ST100 IO&M ERRATA

APPENDIX B – WIRING DIAGRAMS

Figure B-15 – Sink, Pulse/Frequency Output

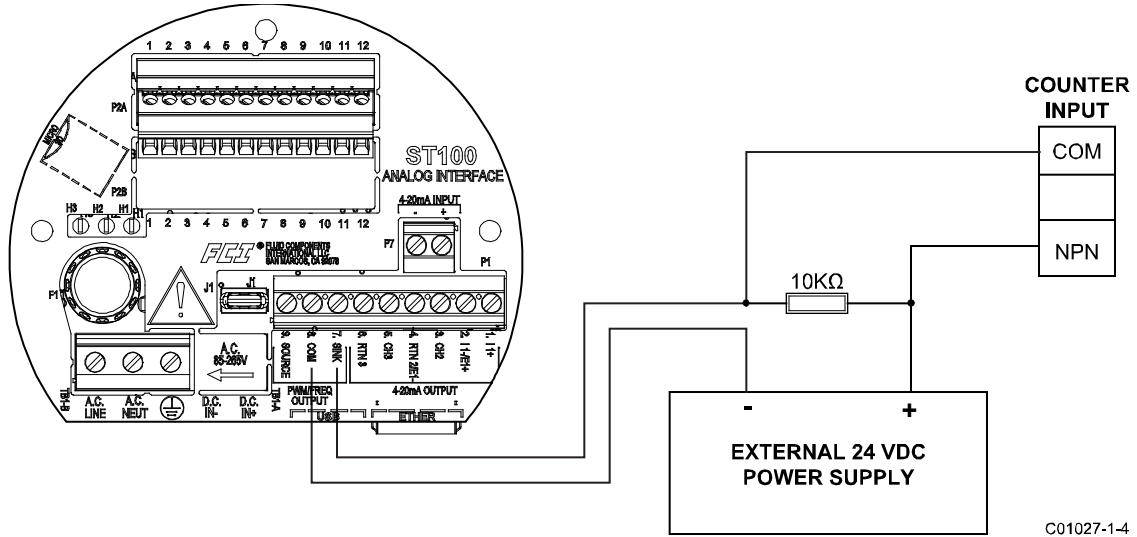
Correct wiring for Figure B-15 (page 67) is shown below.
